FIELD CHANGE ORDER

FIG. 14-013

MANUFACTURING EFFECTUATION LPC 307/17 and upwards.	EQUIPMENT AFFECTED RC 3600 / 6000 RC3641, 3642 / LPT709, 718 and LPC307 Lineprinters and Controller.
NOTE This FCO effects all LPC 307 as indicated under "Manufacturing Effectuation", but also RC3641 (LPT709) and RC3642 (LPT718), if connected to LPC 307.

FIELD CHANGE ORDER

LPC 307
R-11564BUSY AND STROBE LOGIC
LOGIC DIAGRAMLPC
7

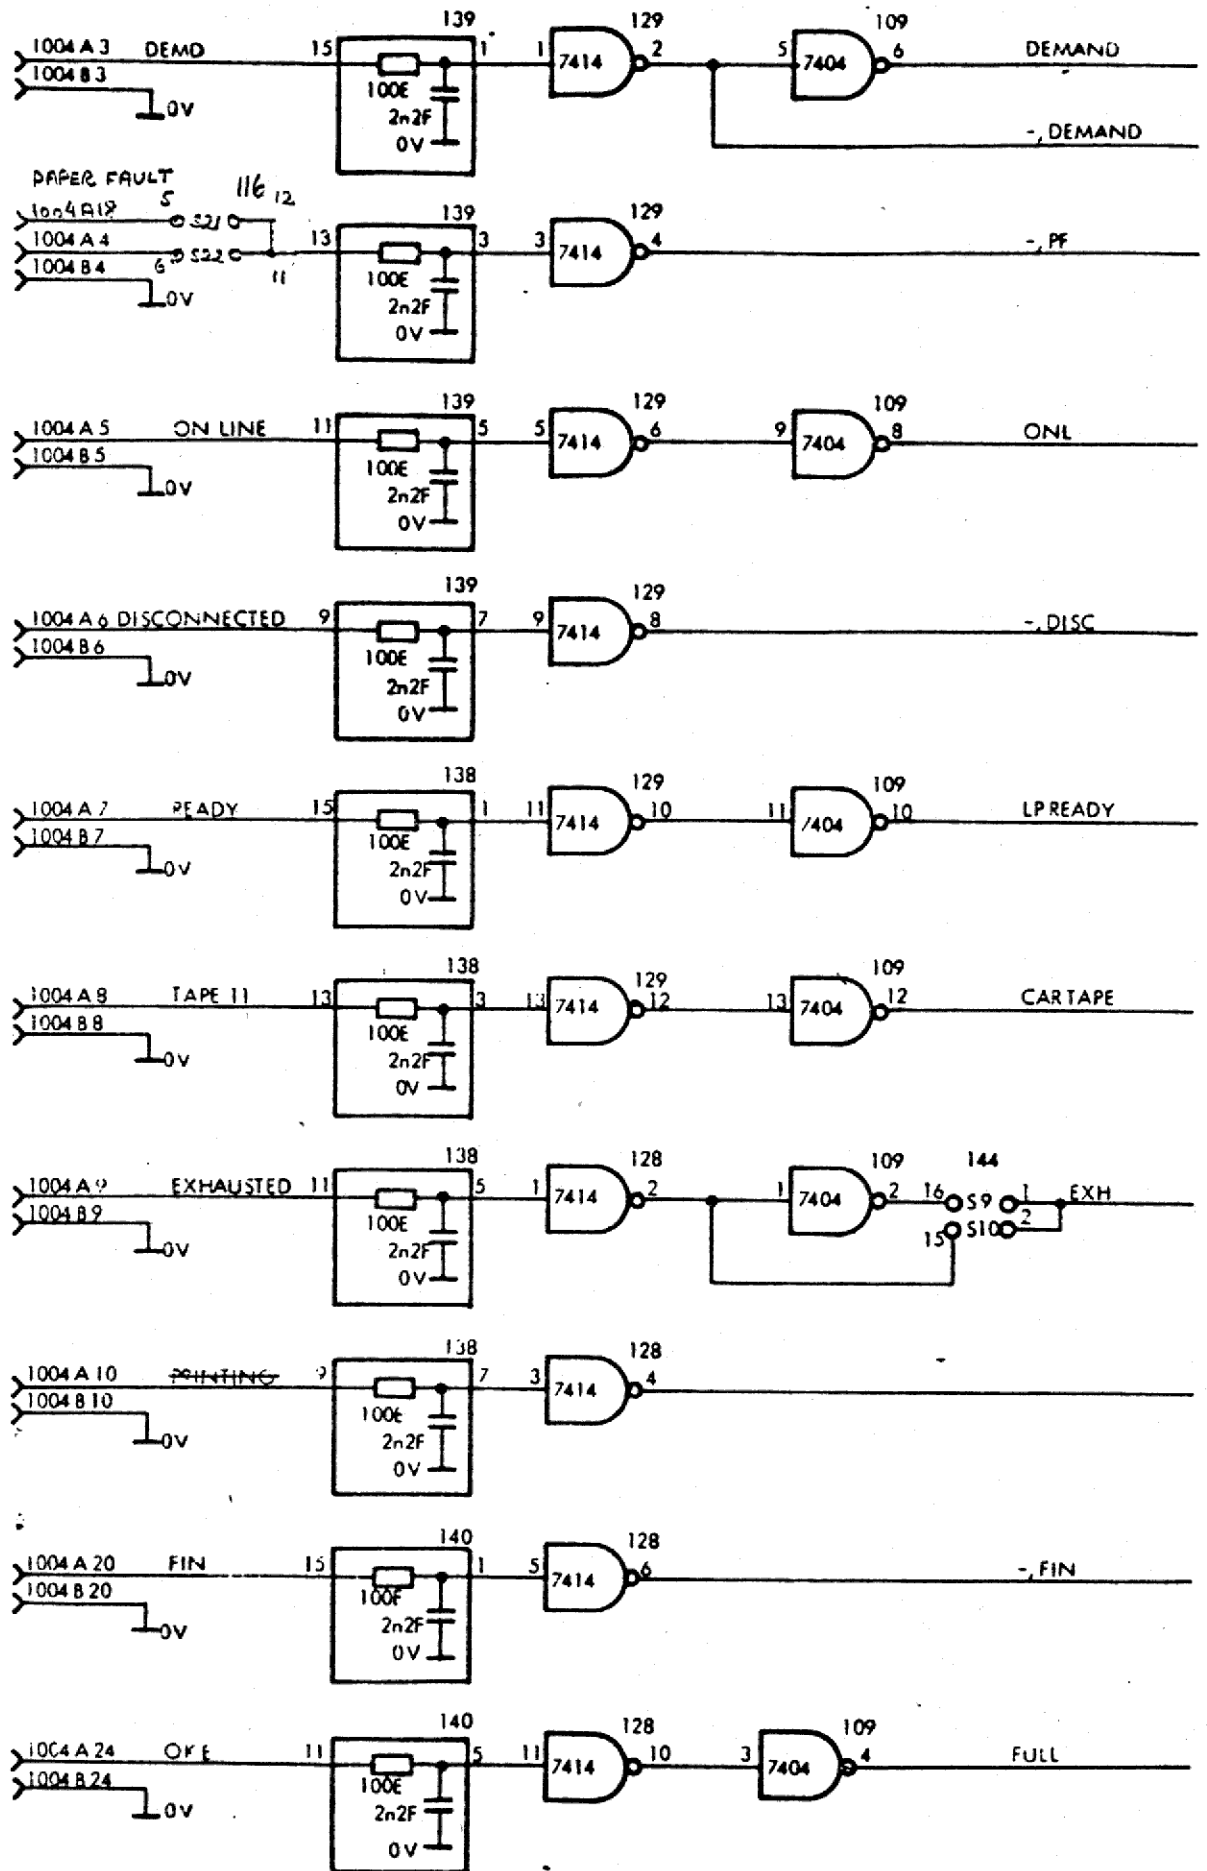
A. Modification on LPC 307.

1. Remove the connection 1004A4 → 139-13
2. Remove the connection 1004A18 → ground
3. Insert the connection 1004A4 → 116-6
4. Insert the connection 116-11 → 116-12 → 139-13
5. Insert the connection 1004A18 → 116-5
6. Replace Rom 419 with Rom 422
7. Set the switches (S21, S22) in position 116 to (on,off)
8. Code the FCO-Label 14-013.

LOGIC BOARD CHANGE PL 364 / LOT=24 / DP 2230

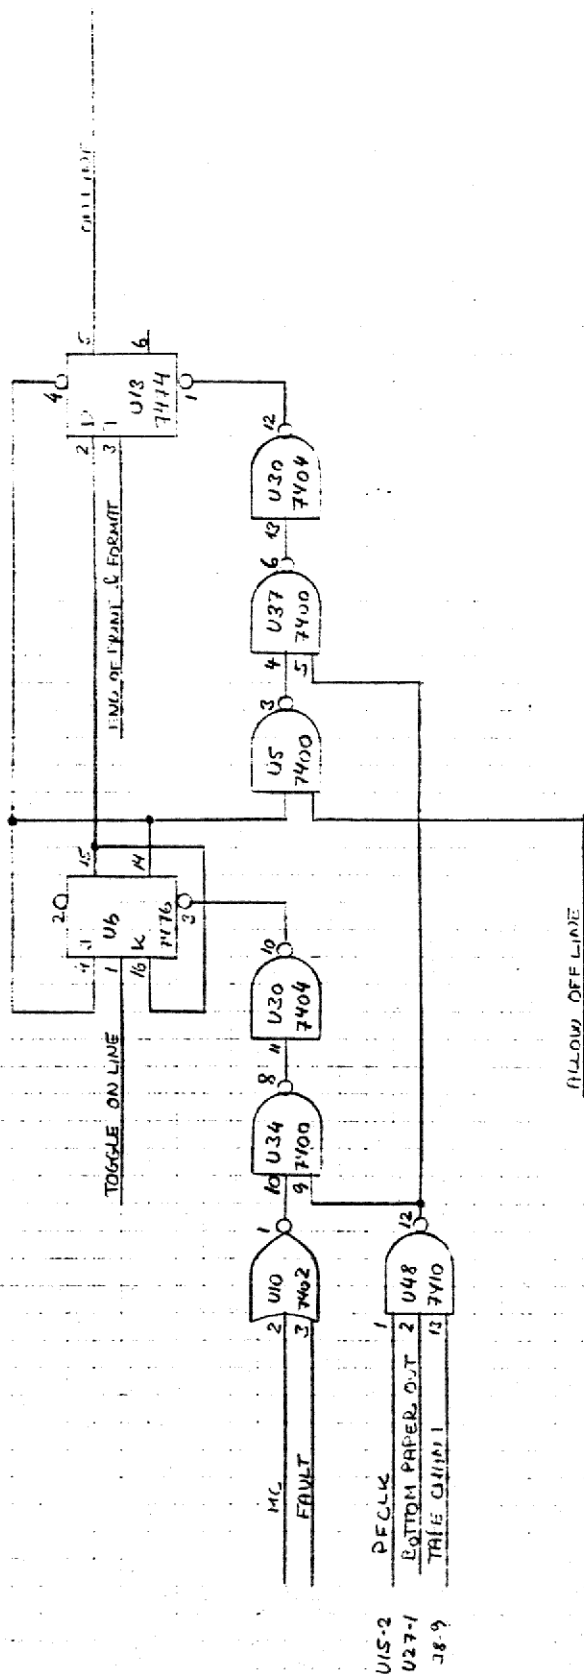
RC 3641 - LPT 724

B. Logic board.

1. Cut the following connections :
J8 - 9 → U22 - 11
U10 - 1 → U6 - 3
U5 - 3 → U13 - 1
2. Insert the following connections :
U22 - 11 → U22 - 12
J8 - 9 → U48 - 13
U15 - 2 → U48 - 1
U27 - 1 → U48 - 2
U48 - 12 → U34 - 9 → U37 - 5
U34 - 8 → U30 - 11
U30 - 10 → U6 - 3
U5 - 3 → U37 - 4
U37 - 6 → U30 - 13
U30 - 12 → U13 - 1
U10 - 1 → U34 - 10
3. Code the FC0-Label 14-015.

LOGIC BOARD CHANGE RL2642 / LDT 725 / DP 2260

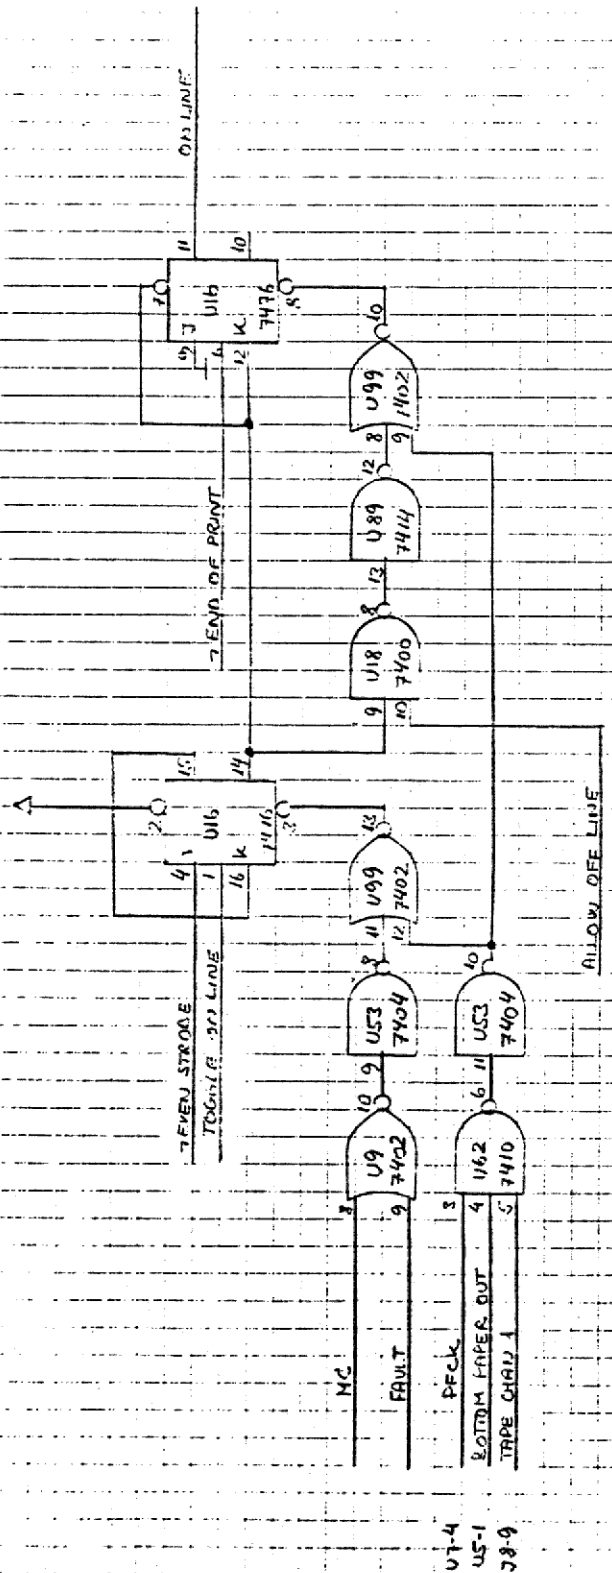
RC 3642 - LPT 725

B. Logic board.

1. Cut the following connections :
J8 - 9 → U35 - 2
U9 - 10 → U16 - 3
U18 - 8 → U16 - 8
2. Insert the following connections :
U35 - 2 → U35 - 3
J8 - 9 → U62 - 5
U5 - 1 → U62 - 4
U62 - 6 → U53 - 11
U9 - 10 → U53 - 9
U53 - 8 → U99 - 11
U53 - 10 → U99 - 12 → U99 - 9
U99 - 13 → U16 - 3
U18 - 8 → U89 - 13
U89 - 12 → U99 - 8
U99 - 10 → U16 - 8
U7 - 4 → U62 - 3
3. Code the FC0-Label 14-015.

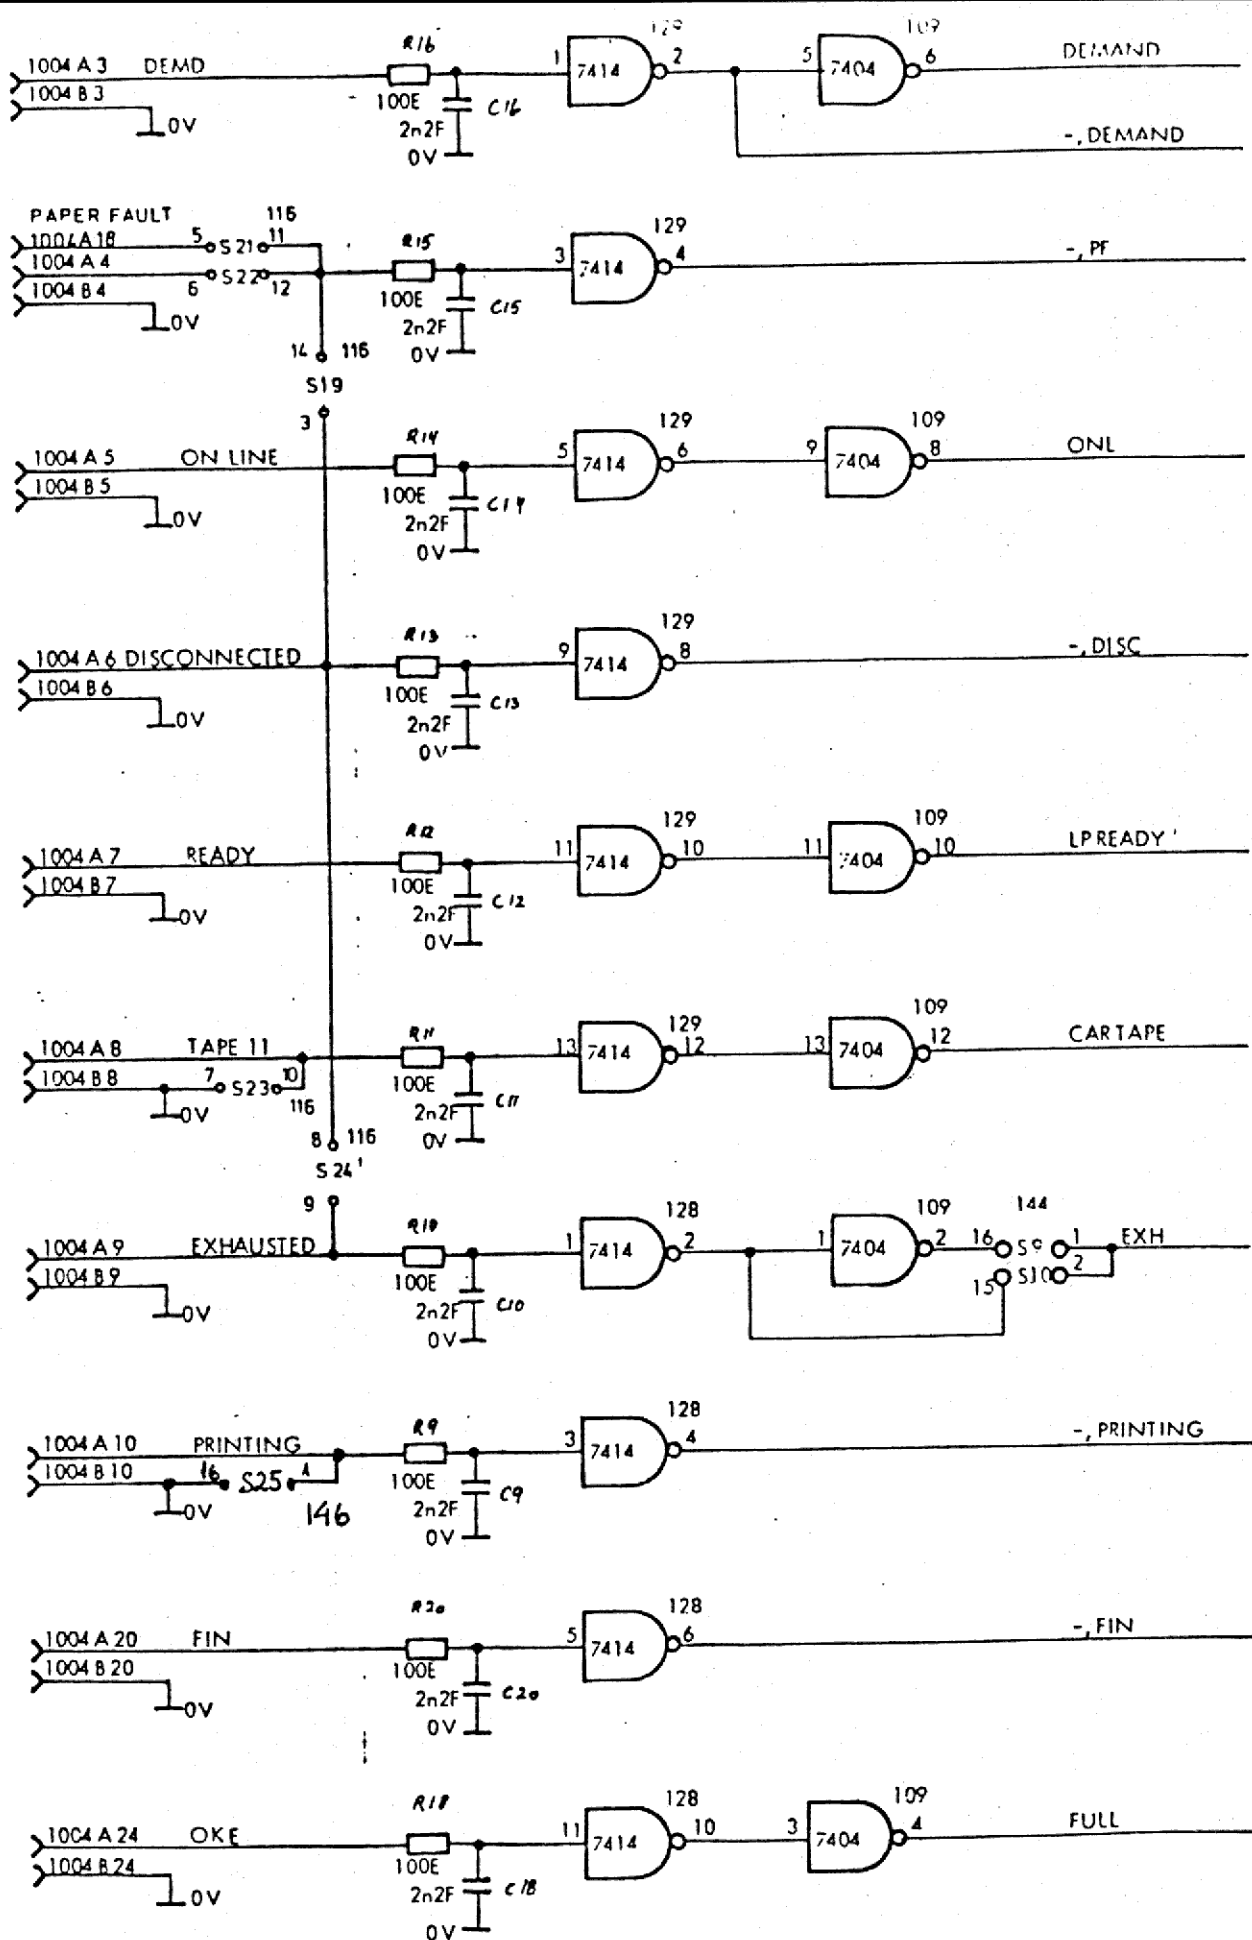
It has come to my knowledge that there might be some difficulties in finding the integrated circuit U99 on the Logic board.

On most boards U99 is positioned in its "natural" position (which means after U98), but in some cases it is positioned between U46 and U54, as shown on the lay-out enclosed.
